Subject: 41-43 Beach Road Collaroy NSW 2097 DA 2019/1522 WRITTEN
SUBMISSION: LETTER OF OBJECTION Submission #6: Buckle & Dorsen

SUBMISSION: BUCKLE & DORSEN
a written submission by way of further objection to DA 2019/1522

Re: 41-43 Beach Road Collaroy NSW 2097
DA 2019/1522

This Written Submission is in response to the submission of **Amended Plans** dated **29 July 2020** on Council website.

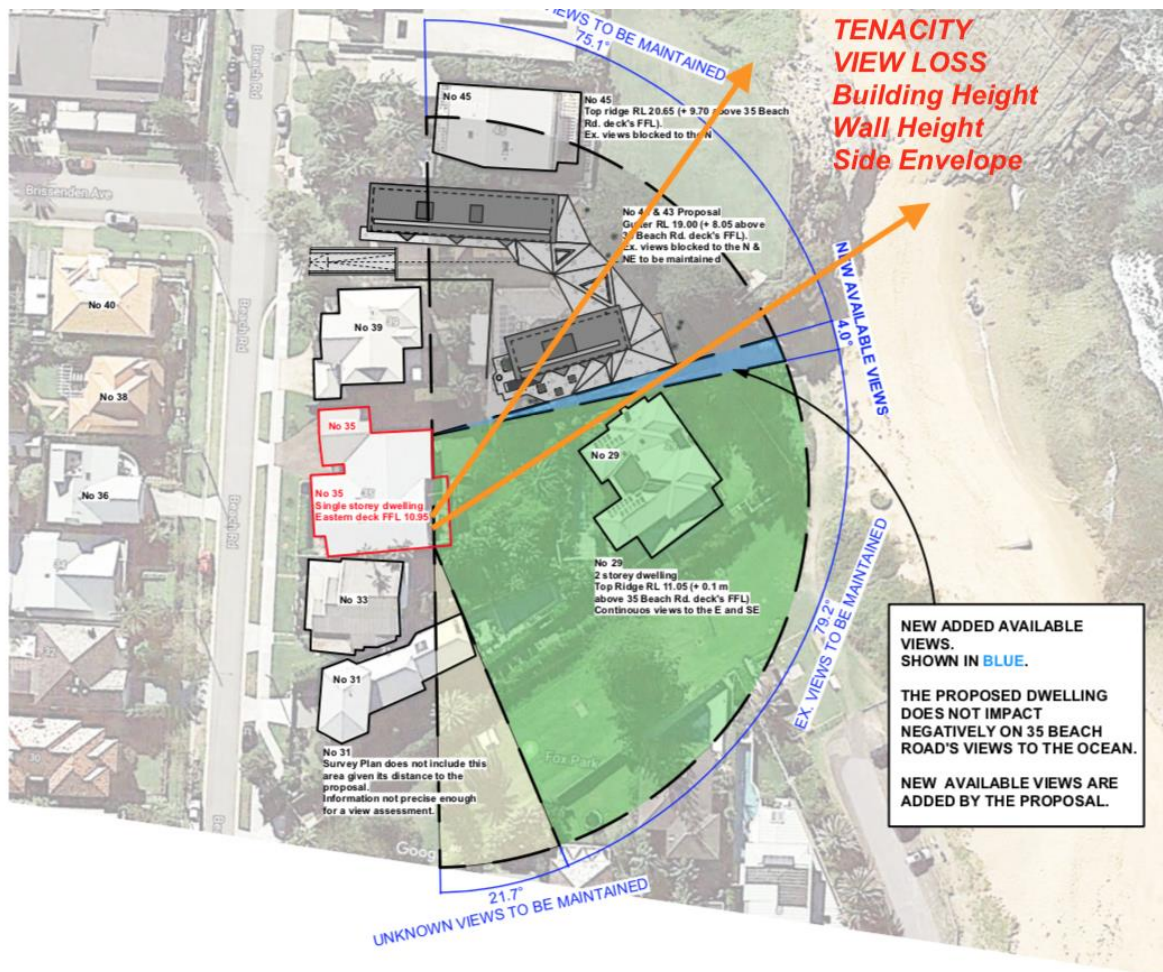
The 'Tenacity' headland view and water view from future upper level is from the Living Room and Deck, the loss is a moderate loss, and the non-compliant development to height controls causes that loss. The loss of the headland view is unacceptable as it provides a natural frame to the view that exists for 35 Beach Road Collaroy, and for many elevated houses to the south that share this view.

The applicant has failed to even correctly identify the location of the Living Rooms on their very limited plan consideration.

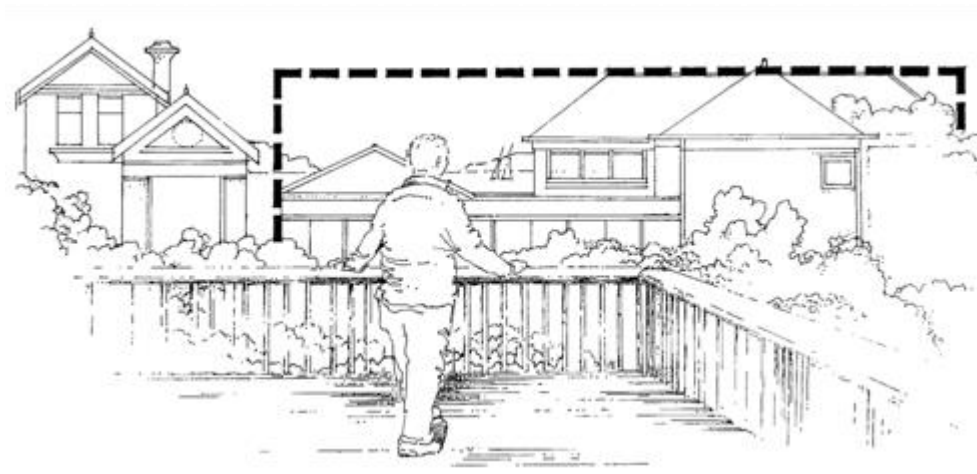
As the proposed development does not comply with outcomes and controls, that are the most relevant to visual impacts, greater weight would be attributed to the effects caused.

In my opinion the extent of view loss considered to be greater than moderate, in relation to the views from my living rooms and living room deck of my dwelling, particularly to the north and east towards the water view.

The view is from a location from which it would be reasonable to expect that the existing view, could be retained especially in the context of a development that does not comply with outcomes and controls.

Where there is a potential view loss, Council should require a maximum building height of less than 8m for part of the building, and should consider other modifications to the design to achieve view sharing.
